CITY OF HOOD RIVER

BEFORE THE CITY OF HOOD RIVER PLANNING COMMISSION HOOD RIVER, OREGON

In the matter of a Conditional Use,
Planned Development, and Subdivision
application by Surround Architecture
to construct a 10-lot subdivision
for 8 townhomes & 2 detached single-
family dwellings called Hazel Ridge
PUD; File No. 2021-07

FINDINGS AND DECISION

SITE PLAN

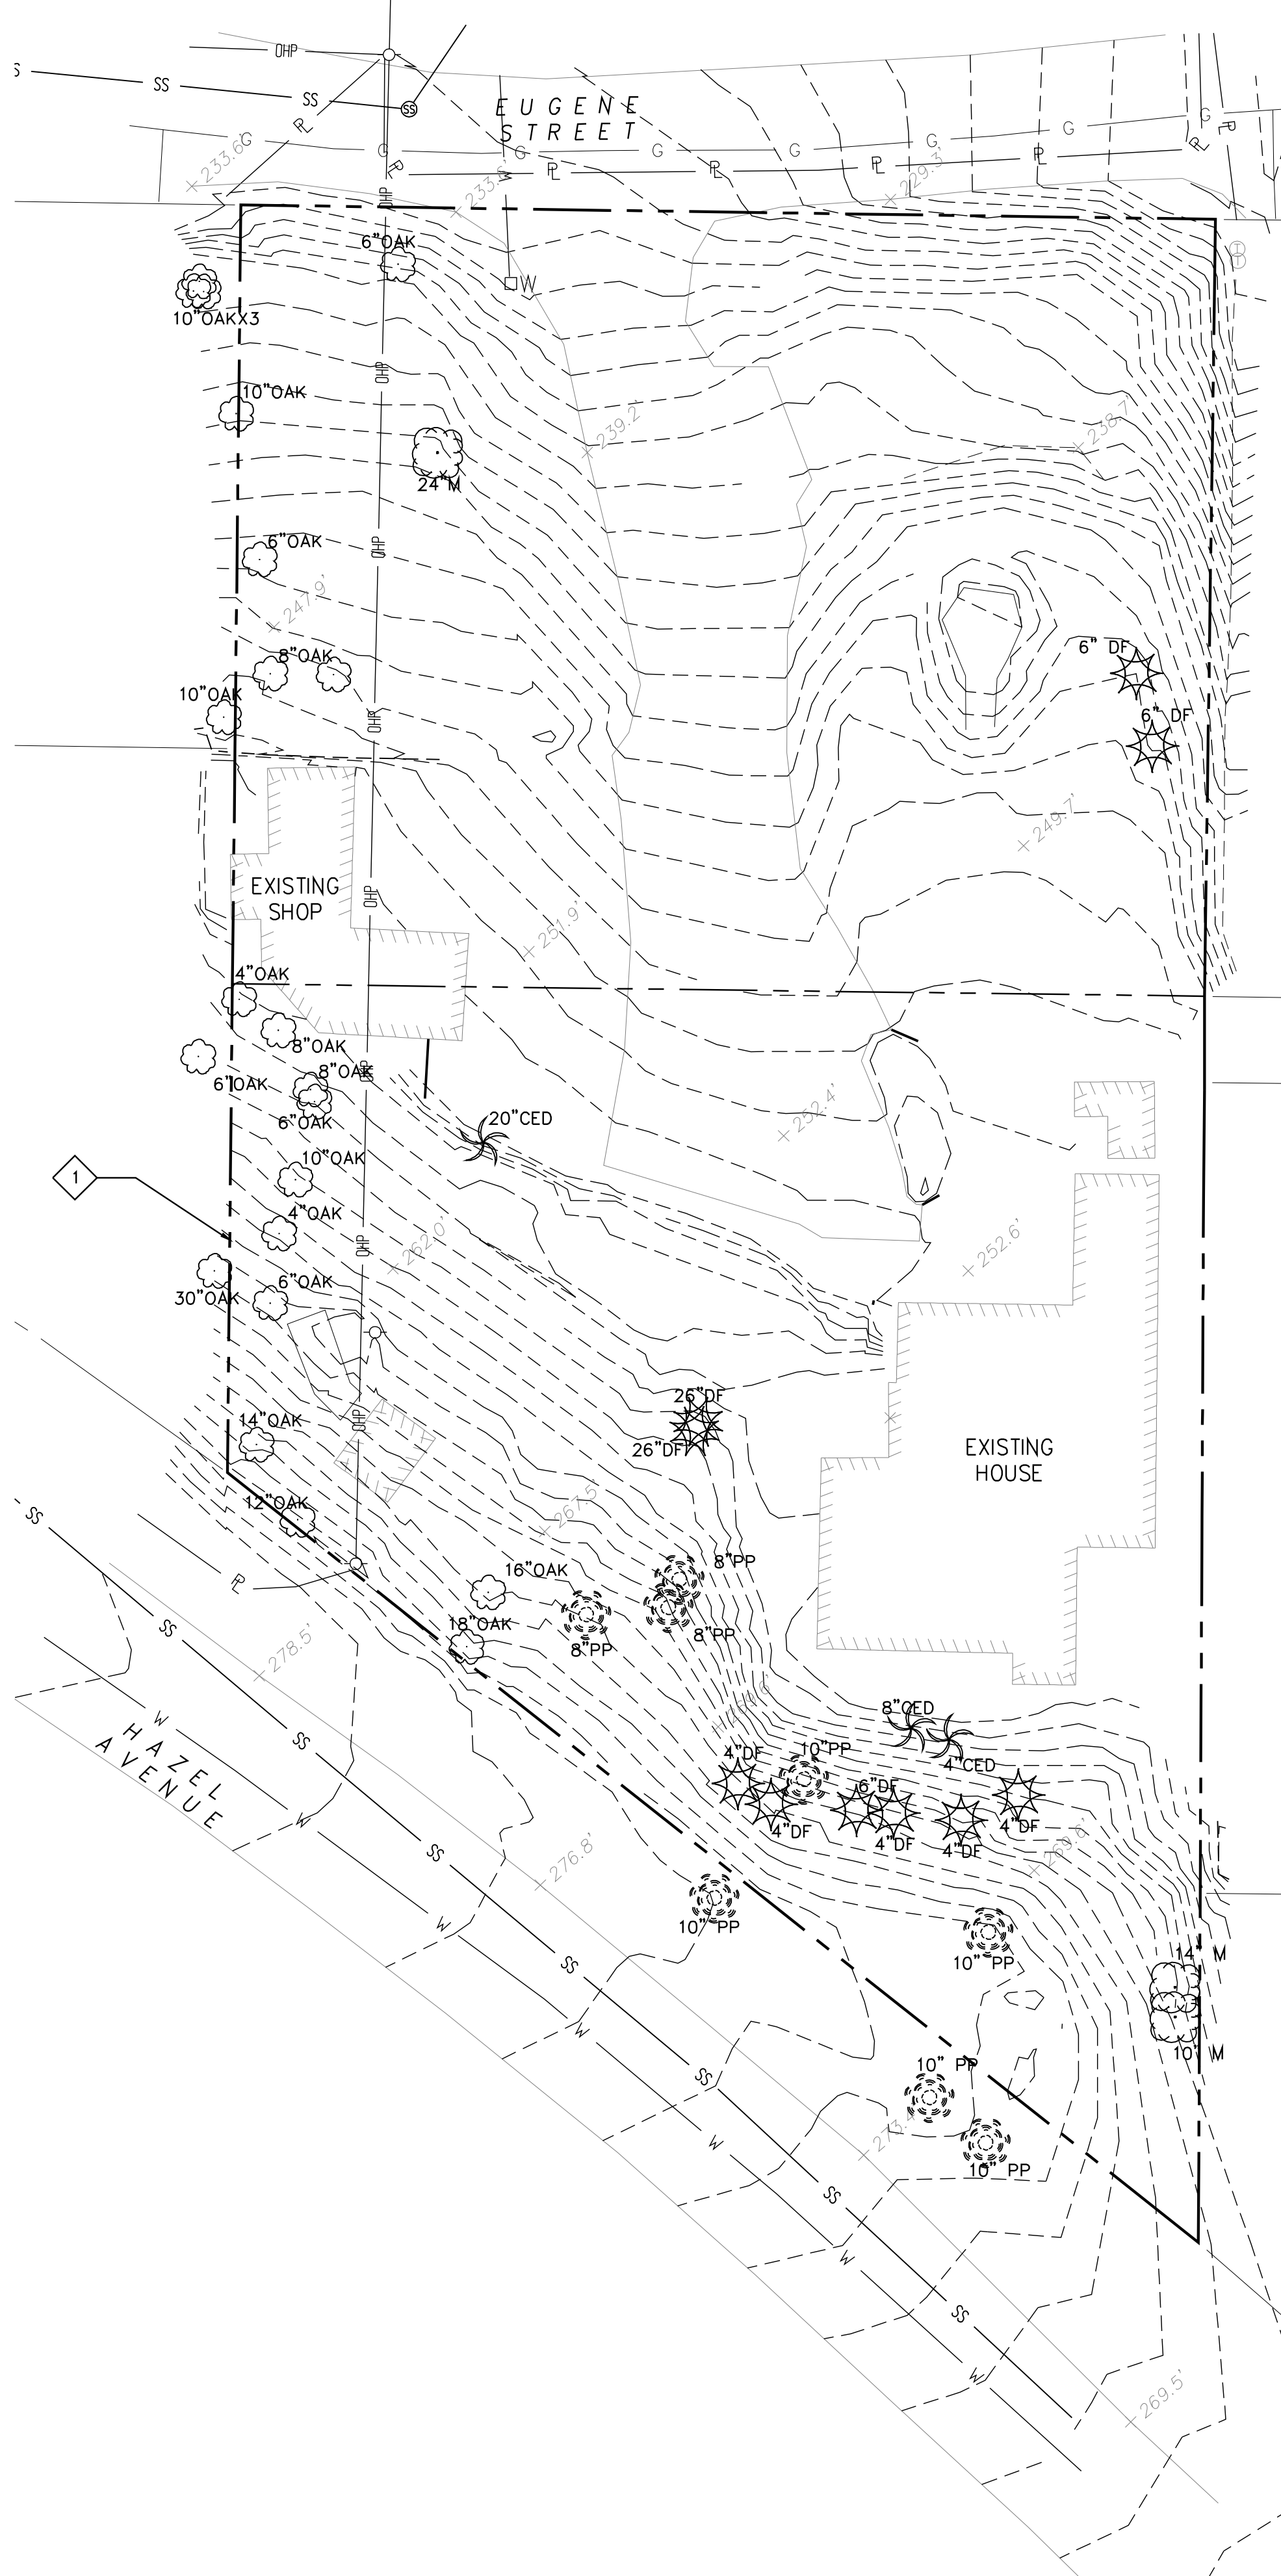
As depicted on the Preliminary Site Plan (Sheet A111, Attachment A.1), a 10-foot setback is noted along the E. Hazel Avenue right-of-way on the south and the E. Eugene Street right-of-way on the north. The Site Plan also depicts a 5-foot setback on the east and west sides. As explained below, the proposed height of the townhomes appears to be less than 28 feet as measured from existing grade. Sheet A112 of the Preliminary Plans (Attachment A.1) depicts side-access garages in the single-family dwellings (Lots 9 & 10) that do not directly face the public right-of-way to the south (E Hazel Avenue). Garages for the proposed townhomes on Lots 1-4 directly face E. Eugene Street to the north. Although not clearly depicted in the preliminary plans, the applicant explained to staff that the garages for Lots 1-4 will be set back under the second story to meet the 20-foot setback for garages facing a street.

No information was provided about proposed projections in the 5-foot side setback, although the preliminary elevation drawings (Sheet A302, Attachment A.1) indicate no roof eaves are proposed on the east and west sides of the proposed structures.

Drawing 111A "Site Plan Development Plan" does not show the setback required for the garage facing East Eugene.

A112

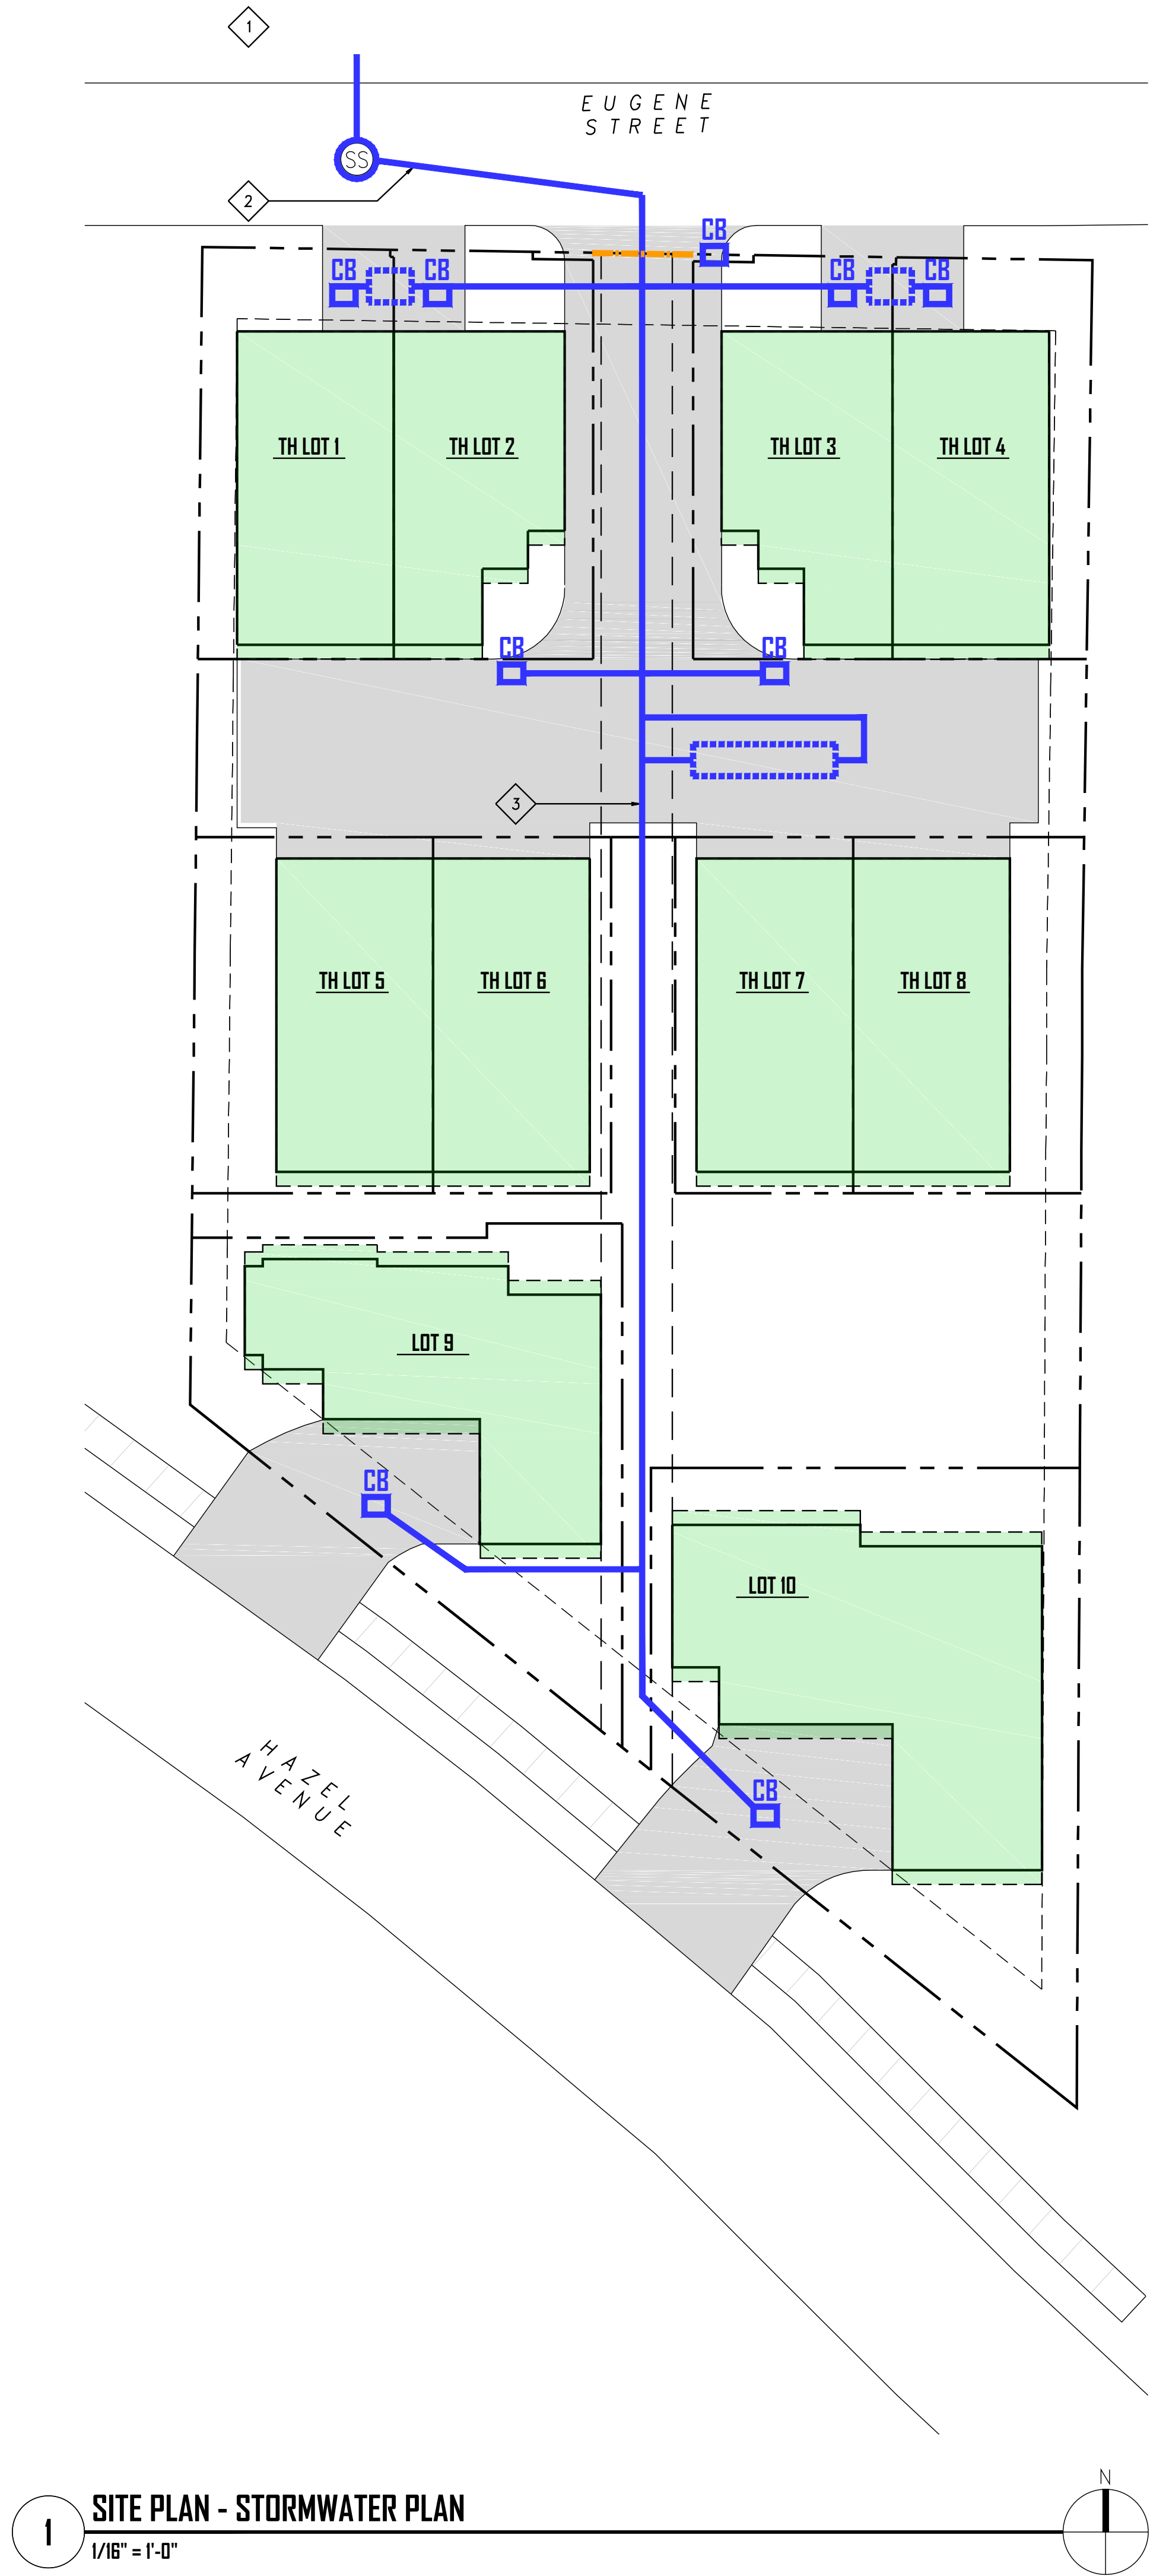
As depicted on the Existing Conditions sheet and preliminary Grading Plan (Sheets A111 & A112, Attachment A.1), the site is sloped downward to the north. The project narrative (Attachment A.2) indicates there is a grade change greater than 10 feet across all proposed lots, however specific existing grade information for each building and building corner was not provided. Building sections depicted on Sheet A401, Attachment A.1, appear to indicate a grade change greater than 10 feet for the two single-family dwellings and the townhouses on Lots 5-8, however additional details will be required to verify this at the time of permitting. It is not clear there is a grade change greater than 10 feet for the townhouses proposed on Lots 1-4. The project narrative (Attachment A.2) and notations on Sheets A301 & A401 (Attachment A.1) indicate the applicant intends the final building plans to meet the 28-foot maximum allowed building height for residential development.

FINDINGS: As depicted on the preliminary transportation plan (Sheet A112, Attachment A.1), the driveways serving the proposed detached single family dwellings access E. Hazel Avenue, a public street, consistent with Option 3. Two shared driveways are proposed to access E. Eugene Street to serve the townhomes on Lots 1 & 2 and 3 & 4, consistent with Option 3. Another shared driveway is proposed to provide access to the townhomes on the interior of the site on Lots 5-8. Comments from the Engineering Department include a requirement to construct this shared driveway consistent with the Six Home Private Street standard (Attachment C). The applicant proposes a private access easement to benefit Lots 1- 10 and Tracts 1 & 2, which appears to be consistent with the intent of Option 2. **A condition of approval is included to require that the**

The applicant submitted a transportation plan (Sheet A112, Attachment A.1) that illustrates a turning radius for fire equipment. The applicant's narrative states, *"All proposed homes are expected to be located within 150 feet of a street. In addition, the shared driveway is designed with proper width and turning radii to provide apparatus access for a aerial ladder truck, and has a hammer head turn around."*

Without the contours being labeled at a specific interval and a stated contour interval, for drawing A11 Site Plan -Existing Conditions, a comparison to the Grading Plan, drawing A112 is not possible. The grading plan only has minimal existing contour information and no clear contour values. As mentioned in my comments from June 10, 2021, there is not a Geotechnical Report in the conditional use application. The Hazel Ridge PUD is predominately located in a Geologic Hazard Zone. The "adverse impacts" from site grading cannot be determined without the Geotechnical Report and adequate grading information.

A115

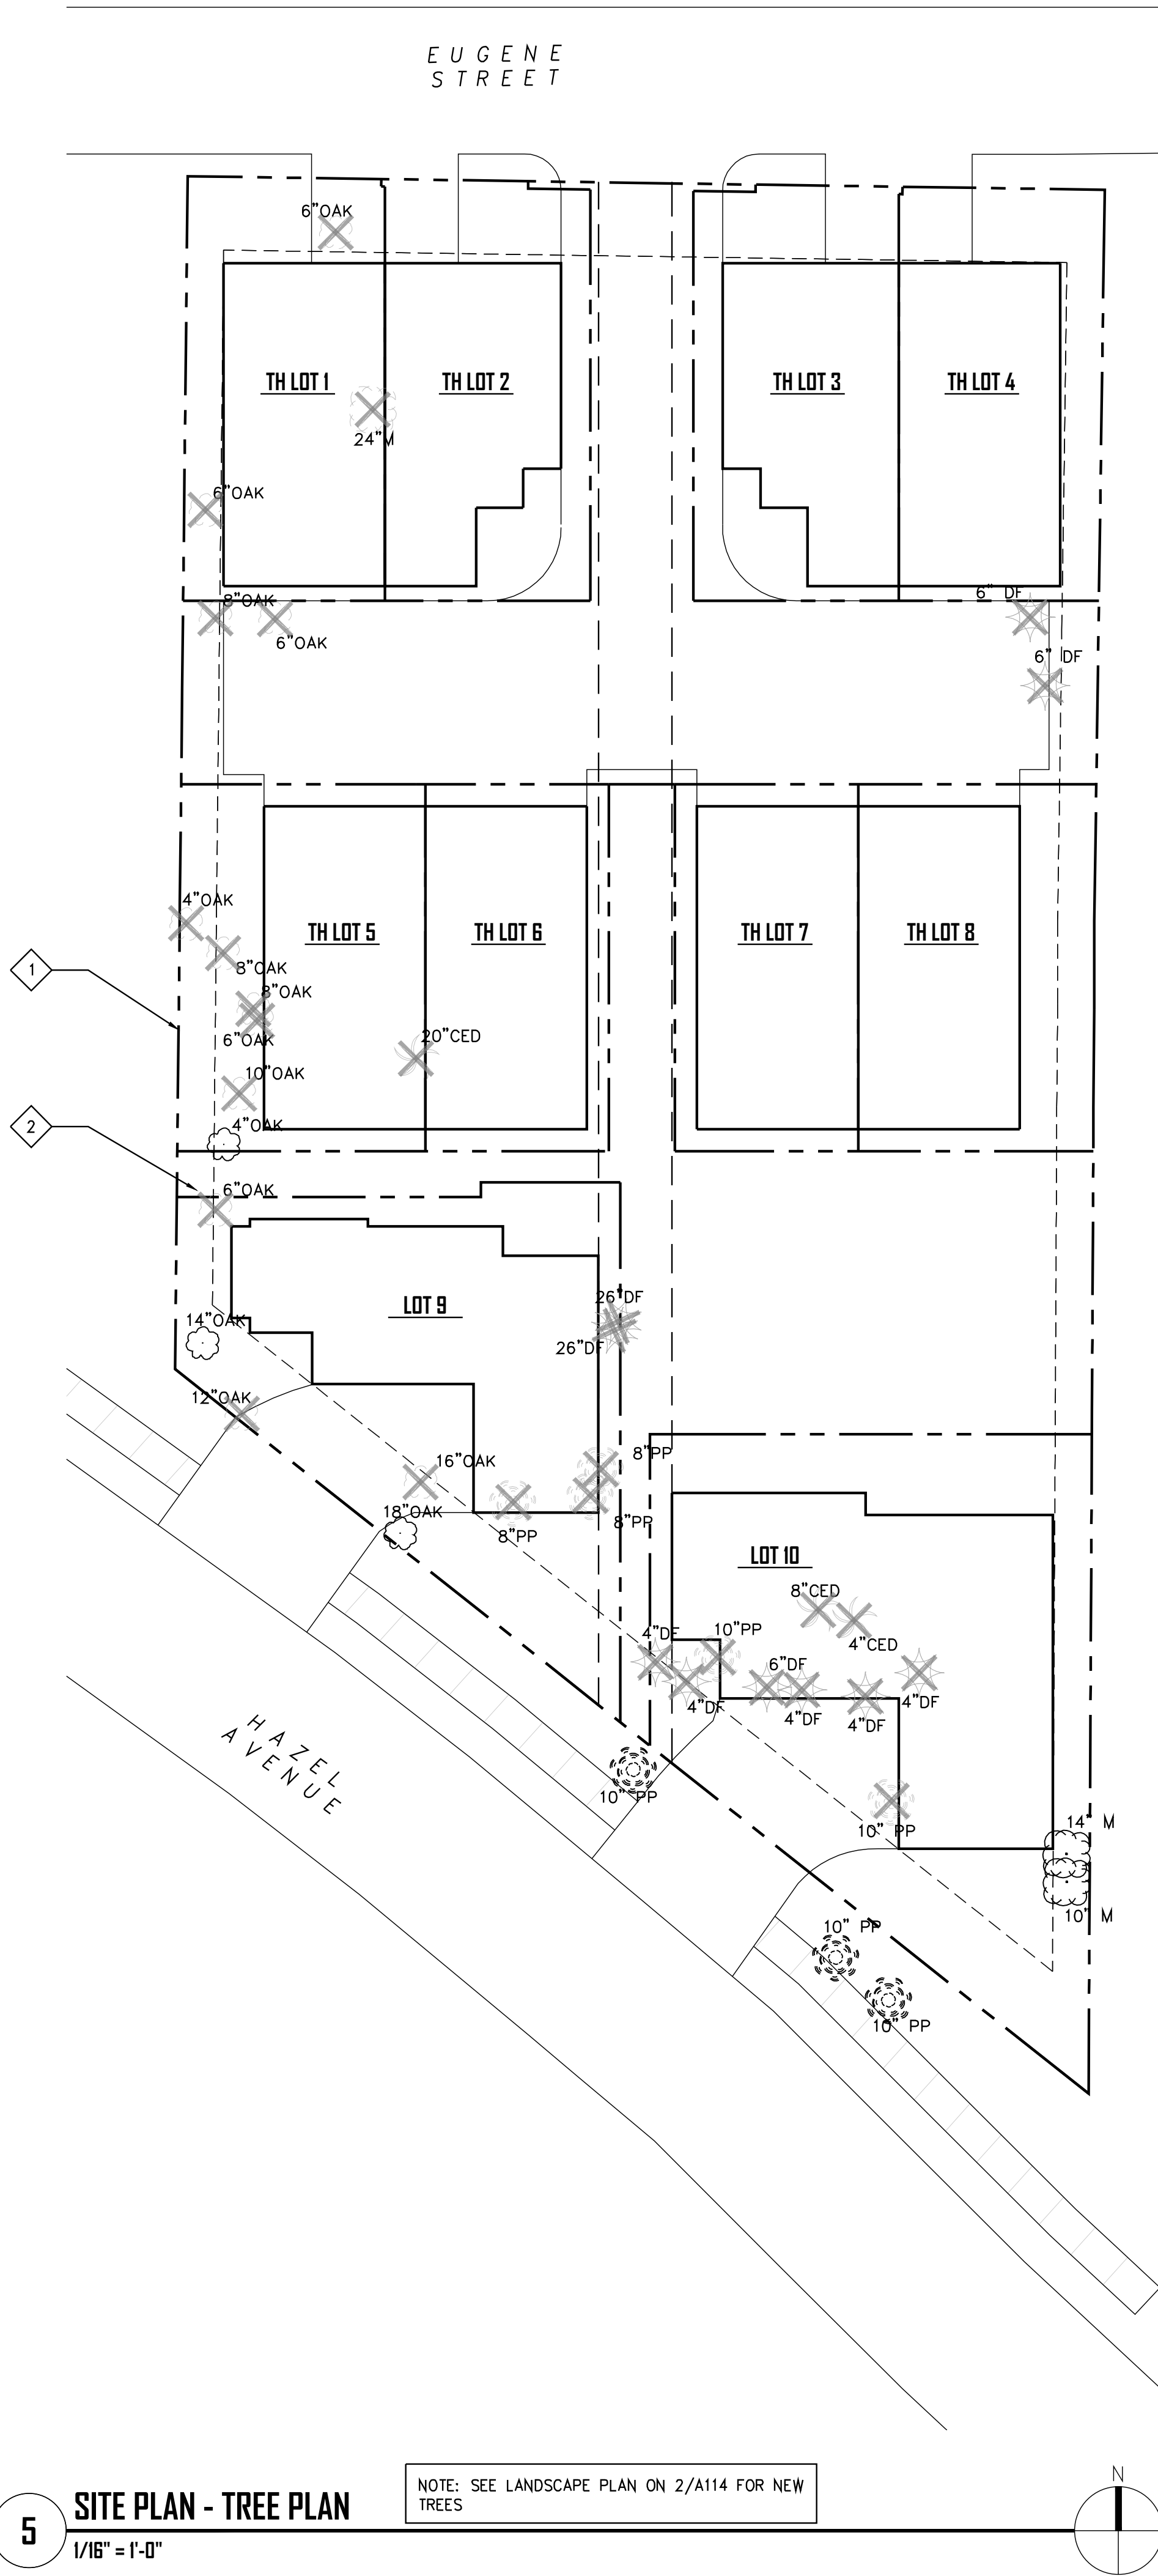
The tree plan on Sheet A115, Attachment A.1 indicates most of the existing mature trees will be removed to accommodate new dwellings or driveways. The plan indicates retention of two oak trees on the southern site boundary, 3 poplar trees in the E. Hazel Avenue ROW, and one other oak tree at the SW corner of Lot 5. Comments from the Engineering Department include a requirement to protect all trees in the rights of way:

The site plan drawing A115 - Site Plan Retaining Walls shows a poured concrete wall for the perimeter of the property. The applicant submitted a new document to the City planning department after the application was deemed complete, titled "Rockwall's at Property Edge," showing a stacked rock retaining wall. The property to the East of Hazel Ridge also has a stacked rock retaining wall. Hazel Ridge PUD is located in a Geologic hazard zone; the GeoTechnical Report has not been provided as part of the application deemed complete. The applicant has not addressed the addition of the stacked rock wall in the project narrative.

4' MAX HEIGHT.

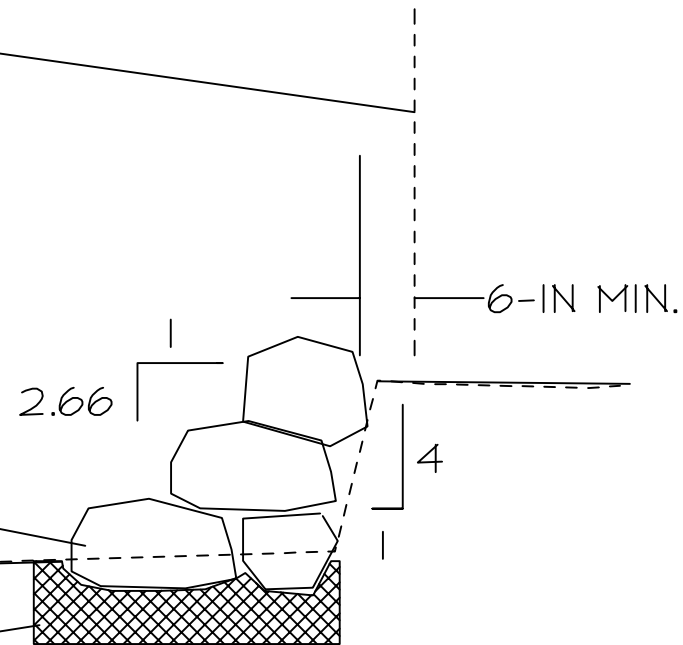
As depicted on the Preliminary Grading Plan and preliminary Retaining Wall plan (Sheets A112 & A115, Attachment A.1) retaining walls are proposed along the eastern and western site property lines and within the 10-foot setbacks on the north and south. Construction details for the proposed retaining walls are included on Sheet A115 to indicate that the retaining walls will not exceed 4 feet in height consistent with HRMC 17.04.060.A. An additional detail of the proposed retaining walls (Attachment A.4) indicates the retaining walls will be located approximately 6 inches inside the side property lines.
